DEVELOPMENT APPLICATION NO: DA19/0875

URBIS RESPONSE TO PENRITH CITY COUNCIL REQUEST FOR ADDITIONAL INFORMATION – 27TH APRIL 2020

Response to RFI Relating to Visual Impacts

NEPEAN GARDENS, WALLACIA, NSW

DATE: 22.05.2020
JOB NO: P0014166
DWG NO: VP_A5
REV: -

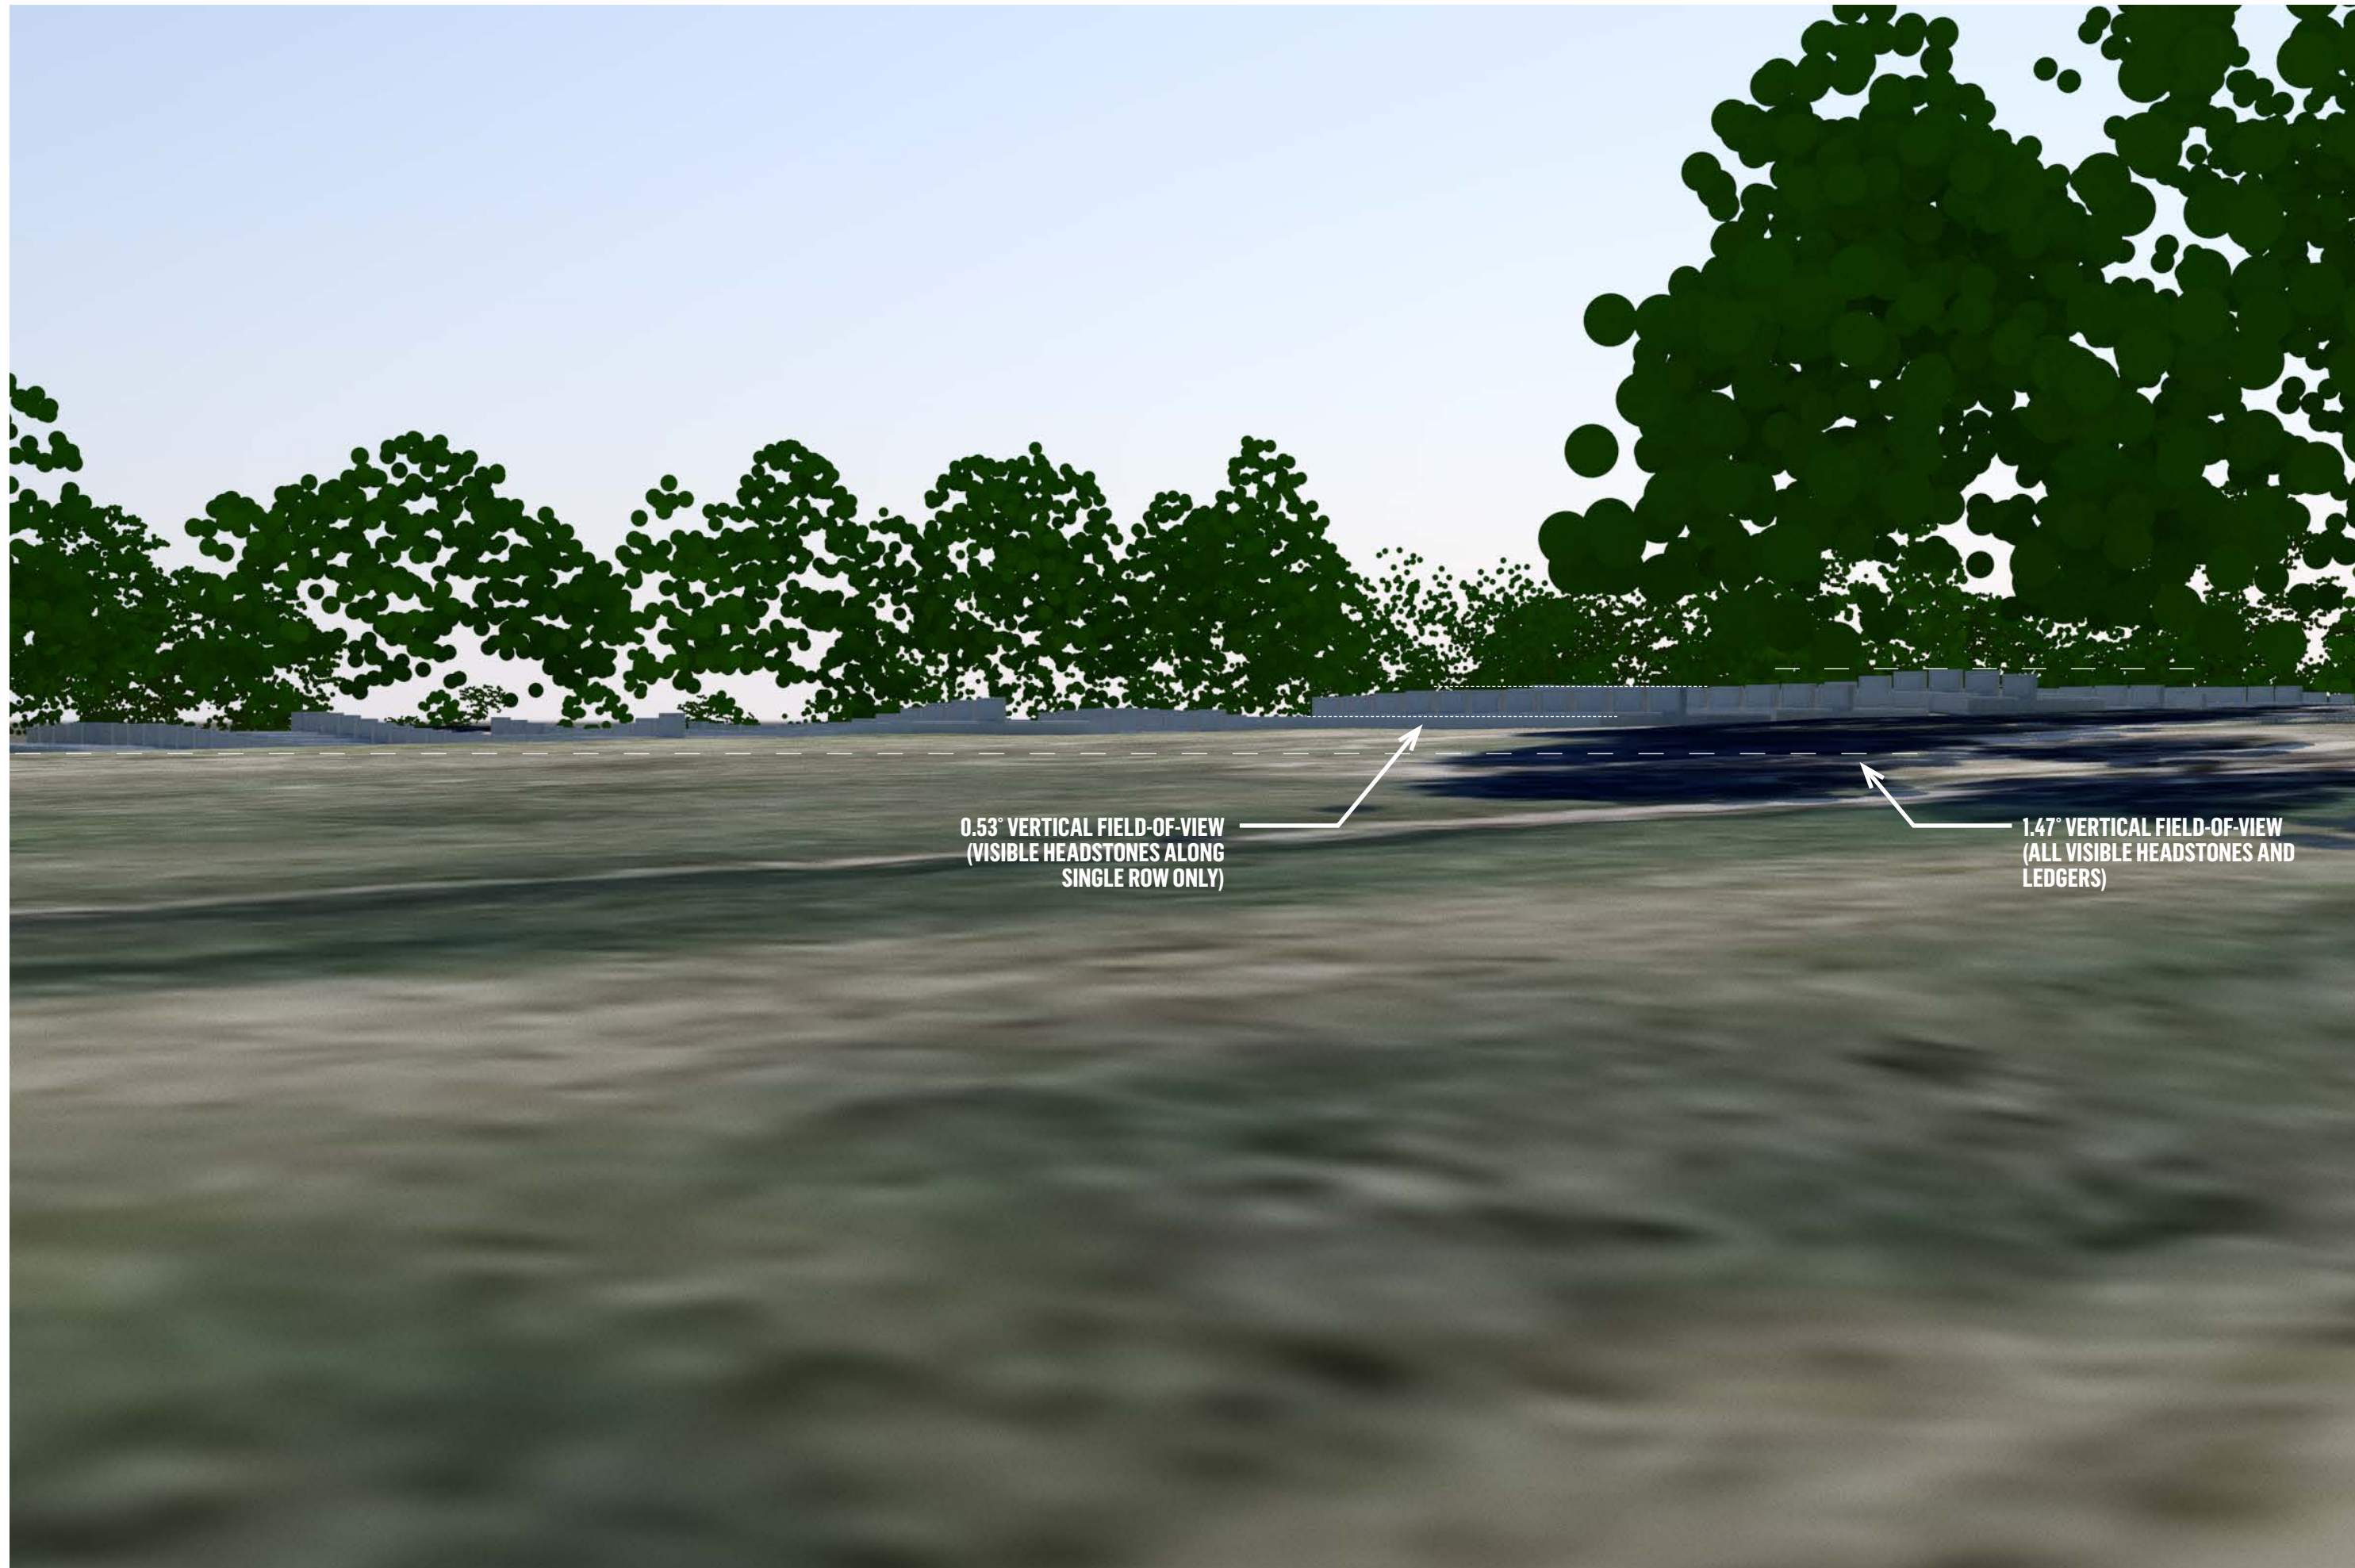
(h) The proposal for Type 3 - 1.5m high memorial head stones is likely to impact poorly on views from neighboring rural residential properties. A response is requested as to why memorial headstones should not be limited in height to 600-800mm, so as to be less visible. The impact of the proposal for Type 4 - Full monumental installations needs to be assessed and in this regard, further detail is to be provided as to the allowable dimensions and locations for this typology. A view analysis or montage may be required.

- VP A – 0.19° vs 0.52°
- VP B – 0.53° vs 1.14°
- VP C – 0.76° vs 1.23°

In all views, the buffer landscaping is highly effective at ameliorating views from surrounding areas. Given the headstones are only 1.5 m in height, buffer planting proximate to viewing location is highly effective in screening views within a relatively short period of time. Post planting, the landscape will gradually reduce views of the monuments. The computer simulations demonstrate that after 5 years, the landscaping will be of a height to effectively screen views to the tops of the monuments.
